Stability Control Sensors

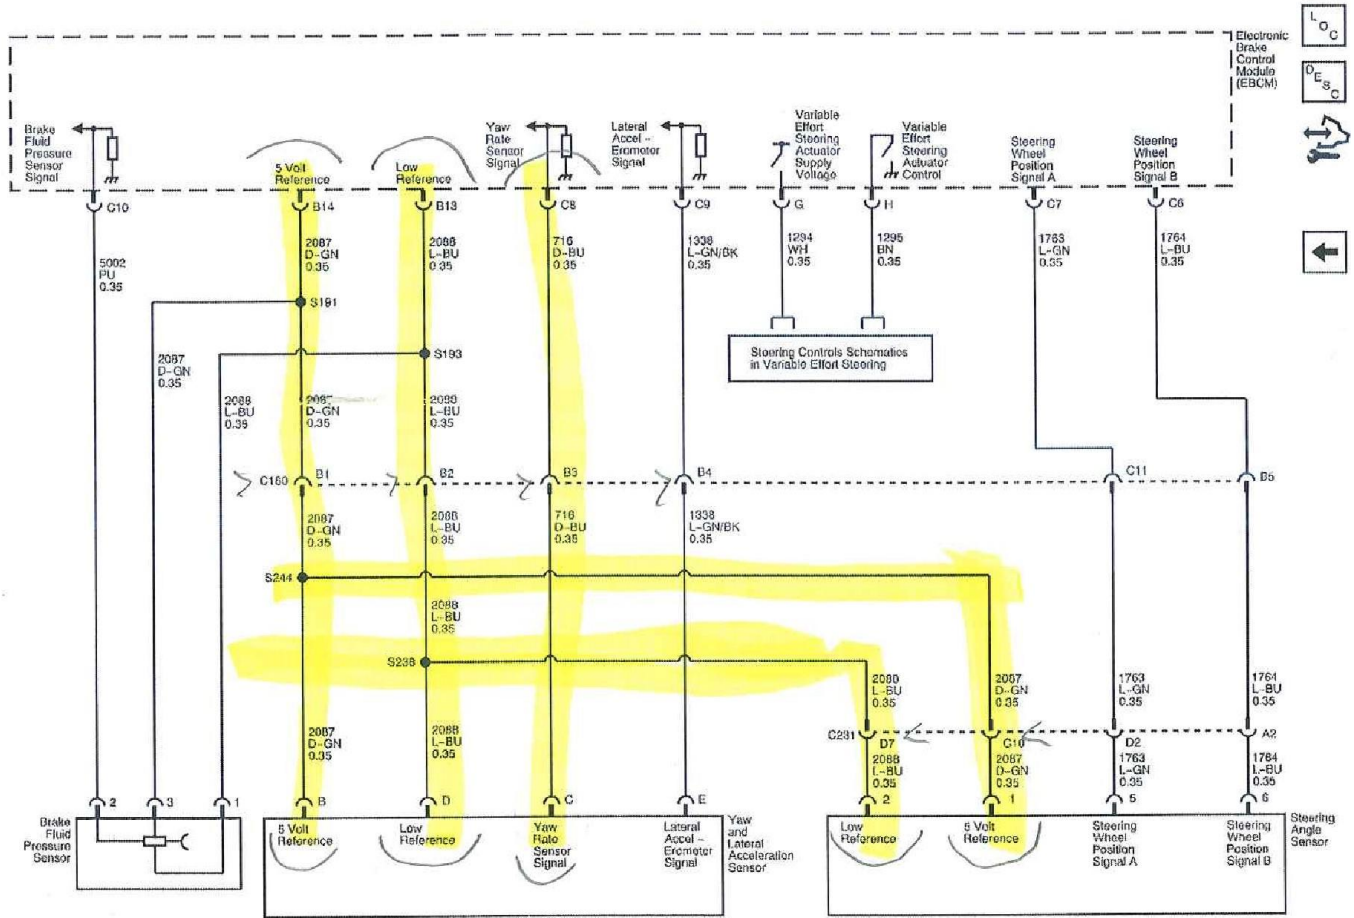
- In-line connectors between start and end points were eliminated, and, start and end connectors were replaced with standard GM connectors.
- Wiring run near the exhaust in the tunnel was relocated to be further from the heat source.
